January 15, 2020

Subject: REQUEST FOR ADDITIONAL INFORMATION REGARDING CHEMPRO TECHNOLOGIES,  
INCORPORATED EXEMPT DISTRIBUTION LICENSE APPLICATION AND SEALED SOURCE  
AND DEVICE REGISTRATION CERTIFICATE APPLICATION

ChemPro Technologies Inc, dba Environics USA, Inc.

## Appendix 2 Radiation Measurement for ChemPro X System and Sensor Unit

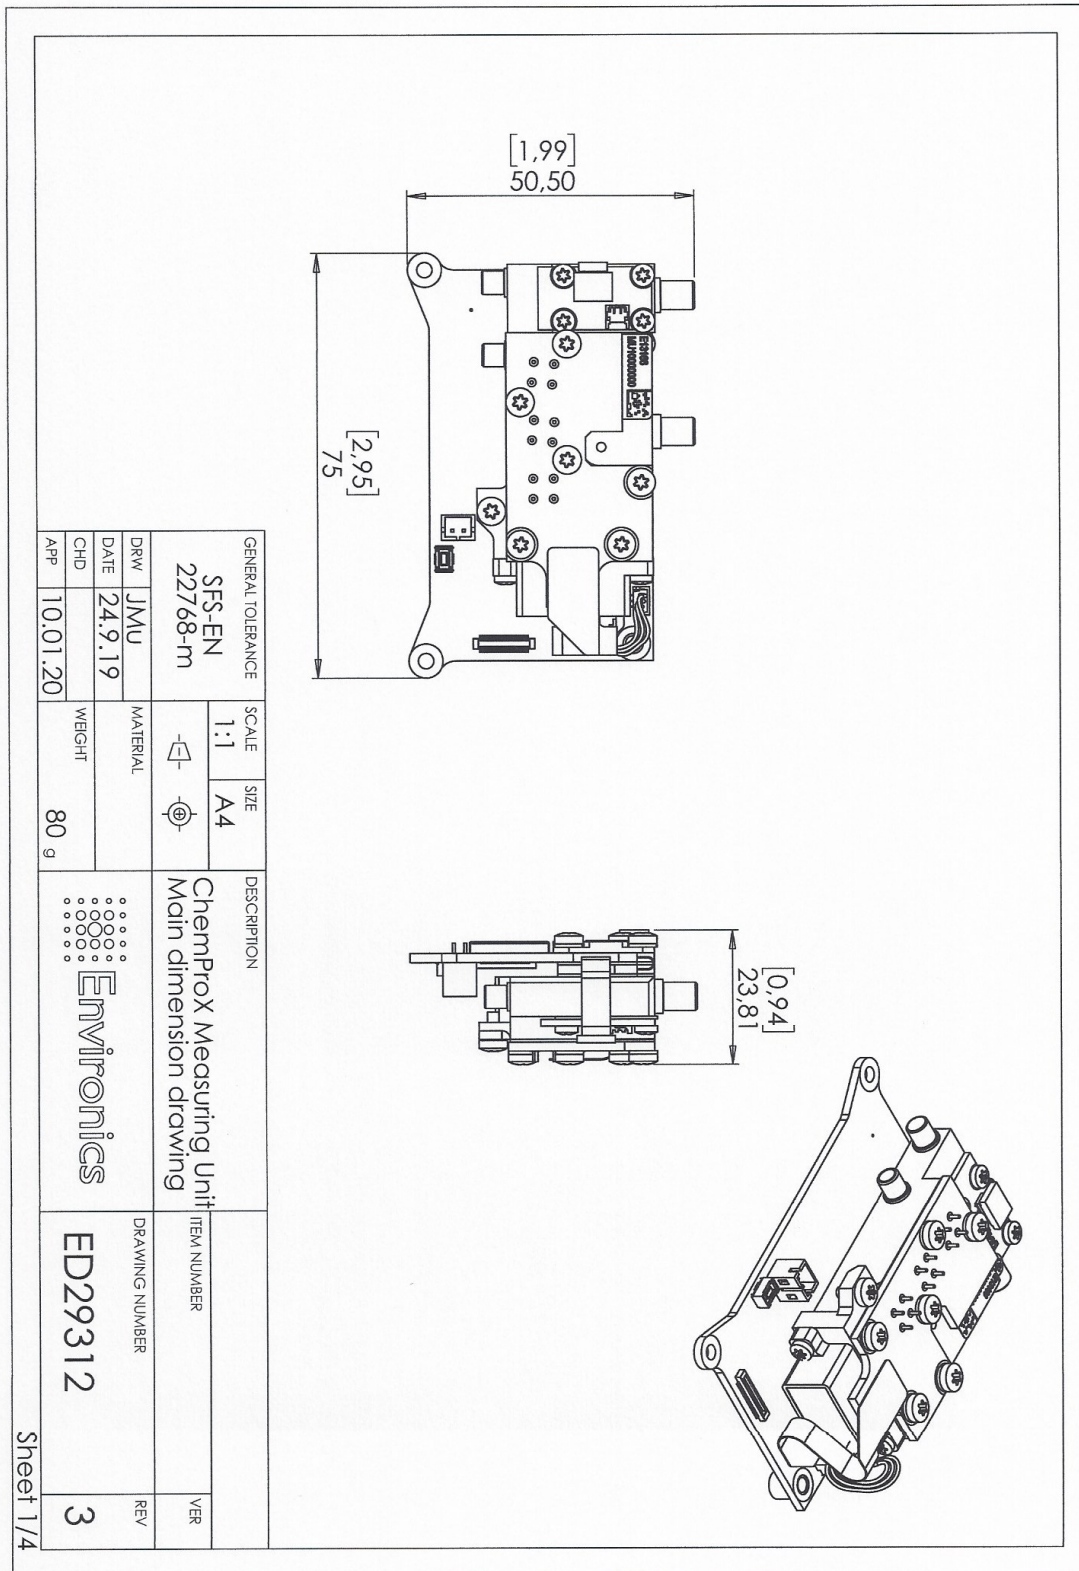
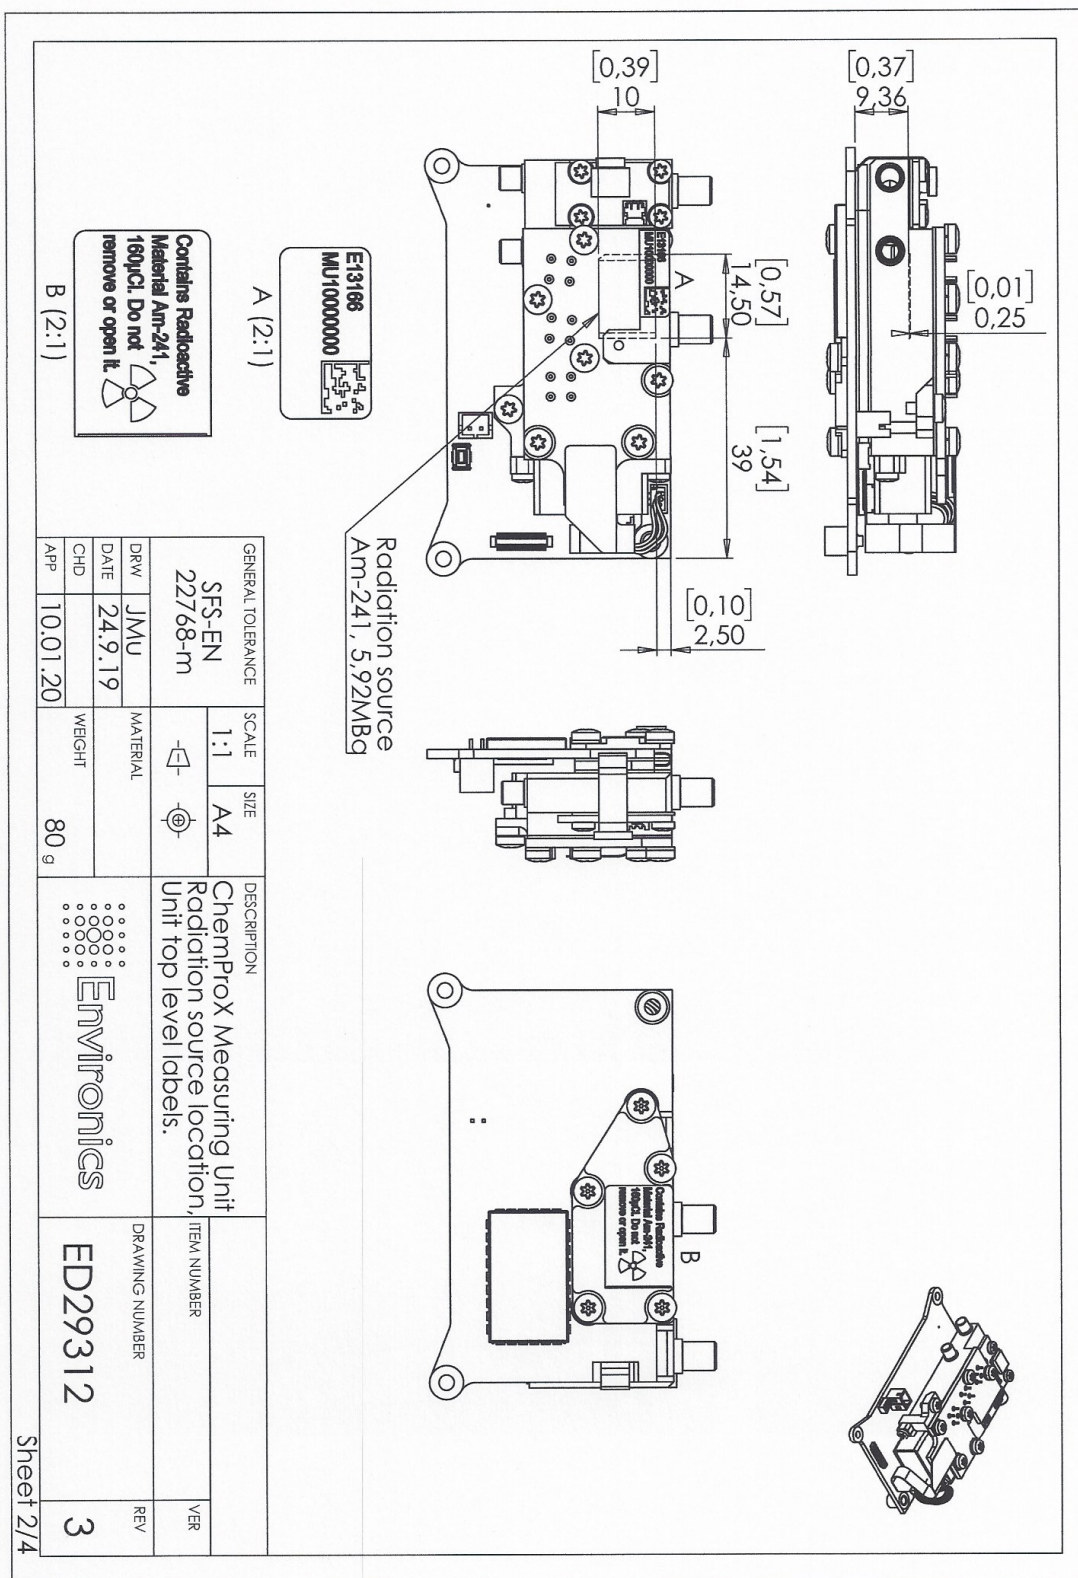
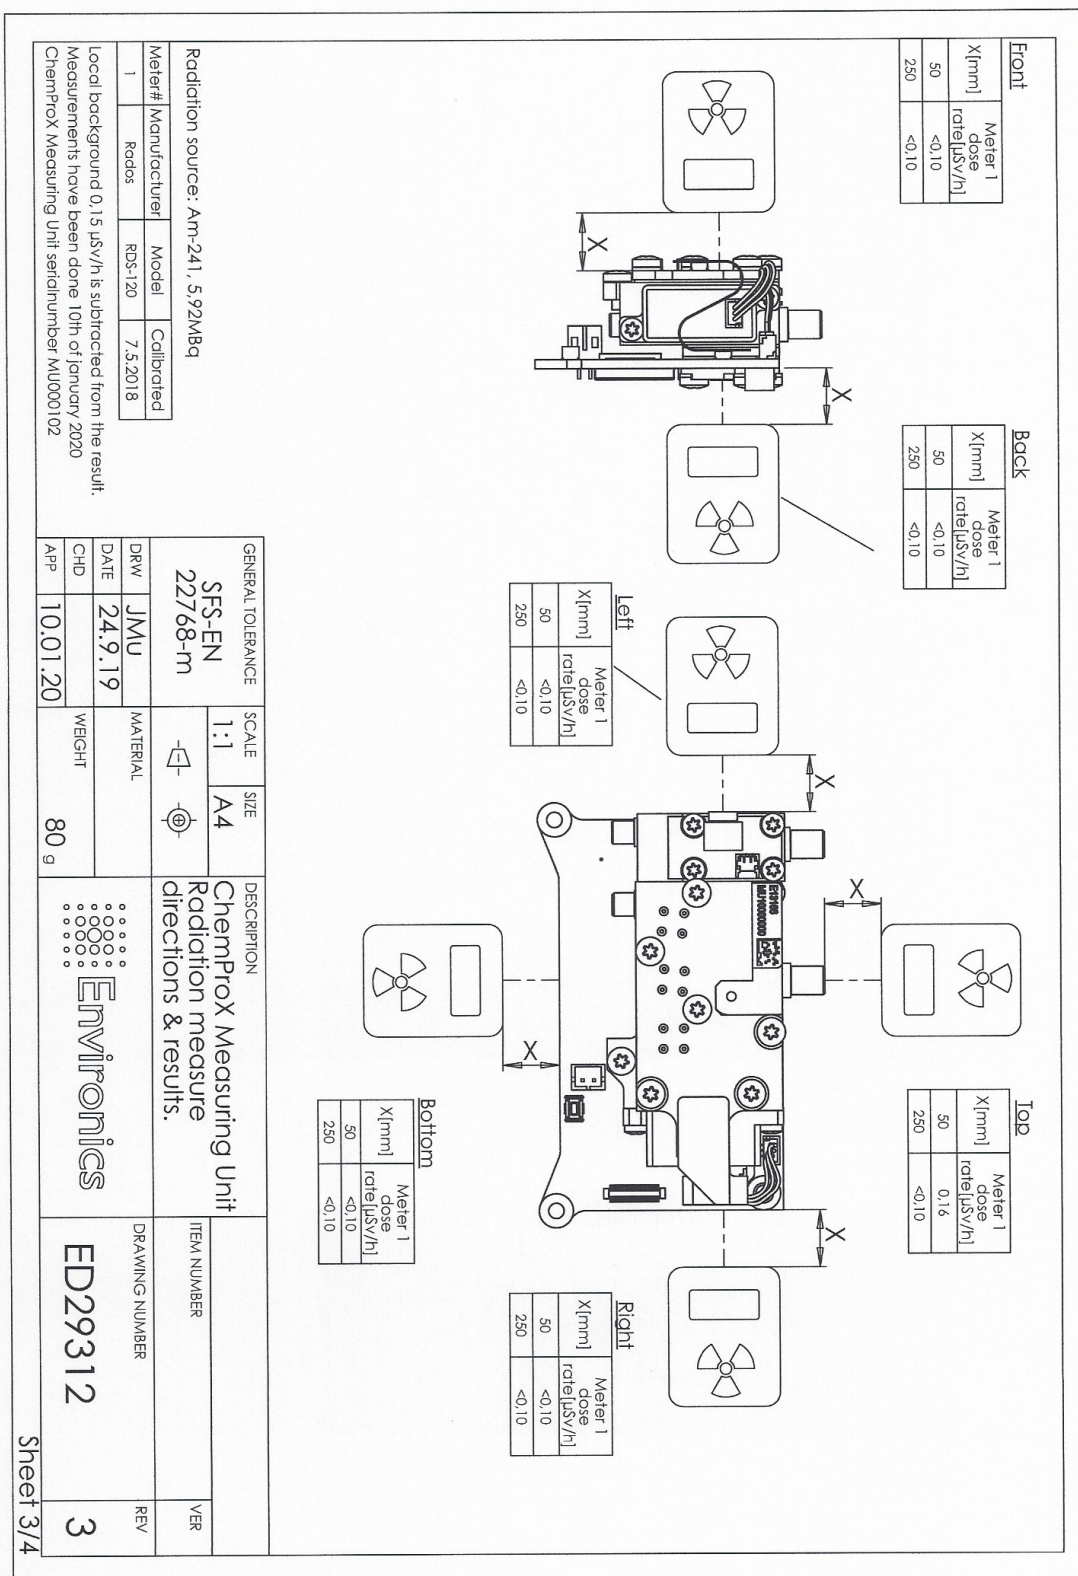
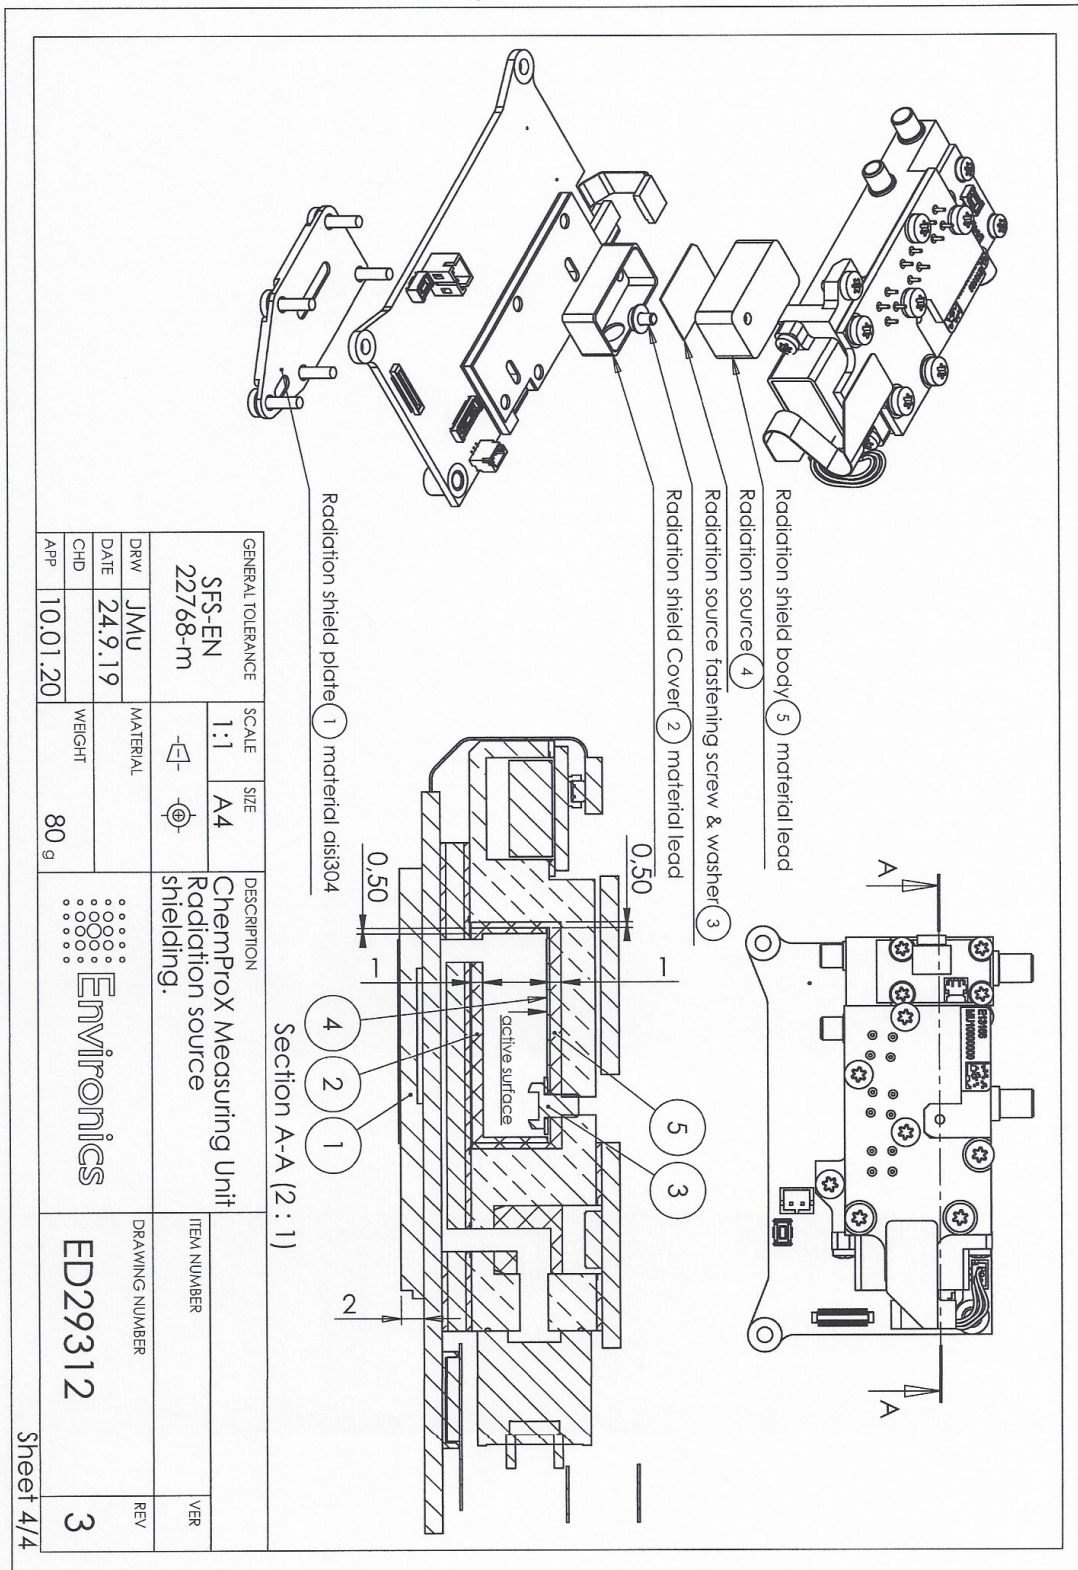
2. Please update your radiation exposure evaluation found in your initial application for the Model X as per 10 CFR 32.26, "Requirements to license to manufacture, process, produce, or initially transfer" as follows:

- 32.26(b)(6) - Maximum external radiation levels at 5 and 25 centimeters from any external surface for the model X, averaged over an area not to exceed 10 square centimeters, and the method of measurement or calculation.

In your letter dated November 13, 2019, under the section titled, Change B, it states that for the new ChemPro X "The max radiation level at 100 mm (3.93 in.) is 27.2  $\mu$ rem/hr." The radiation levels of the previous models were 1.3  $\mu$ rem/hr at 5 cm thus the radiation level is higher at the longer distance. If you experience the same anomaly when you take the radiation measurements at the distances stated in the above bulleted item, please explain the increase in radiation levels between the ChemPro X and the previously registered models in the ChemPro series. Please note that previously submitted radiation profiles do not support the new values.

**Response:** In our previous letter there were incorrect radiation level measurements for ChemProX. Please see attachment "ChemProX drawing ED28002 rev 5, page 3 (Appendix 2) and ChemProX Meas Unit Drawing ED29312 rev 3, page 3 (Appendix 2) for new measurements from distances 5 and 25 centimeters, max radiation level is 10  $\mu$ rem/hr at 5cm.

Upon review of your comments concerning the difference in radiation levels, our research shows that the values listed in the previous license were incorrect. The radiation levels previously measured were <0.1  $\mu$ Sv/h (same as ChemProX) as stated in the STUK test report dated Oct. 2, 2006 (Appendix 3), not 0.01  $\mu$ Sv/h as referenced in the license. It is my understanding that this is the report that was submitted with the earlier license request back in 2006. I can only speculate that a decimal point was misplaced during generation of the previous license back in 2006.

## APPENDIX 4 ChemPro X vs ChemPro100 IMS Sensor Unit Comparison

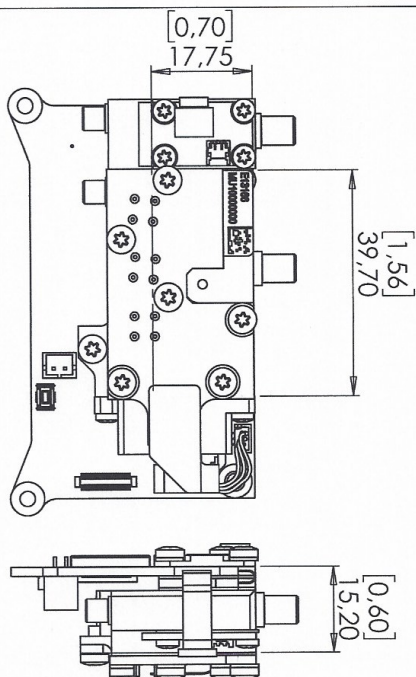
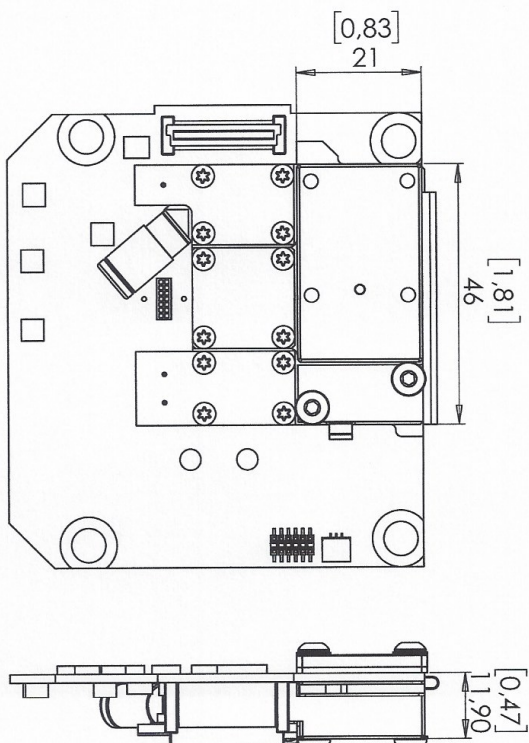
1. We note a change in dimensions in the sensor unit between the previously registered

devices in the ChemPro Series and the sensor unit requested for the ChemPro X. Please describe the difference between the two.

2. Please discuss if there were any changes made to the source shield assembly. This includes any changes in materials or dimensions. If changes were made please provide the prototype testing results and procedures in order to demonstrate that the device will maintain its integrity during normal use and likely accident conditions. Please see NUREG-1556, Volume 3, Rev. 2, Section 10.5, "Prototype Testing", for the forms acceptable prototype testing.

**Response:** Please see attachment ChemProX IMS Sensor Unit Dimension comparison-ED29500 rev 1 in Appendix 4. The radiation source, radiation source attachment, radiation shield material and thickness is the same as ChemPro100i

**Response:** Please see attachment "ChemProX IMS Sensor Unit Dimension comparison-ED29500 rev 1 (Appendix 4). The source shield assembly is same as previous ChemPro Models, only miniaturized. ChemProX is ruggedized device designed for military use. It is tested against MIL-STD-810G for drop test, general vibration test and loose cargo test. These reports are submitted in Appendix 5 for your review. We assume that no need for more testing to demonstrate that the device will maintain its integrity during normal use and likely accident conditions.

IMS sensor unit in ChemProX is miniaturized version of previous version IMS sensor unit.  
Radiation source, radiation source fixation, thickness of radiation shields are exactly same as in previous version.
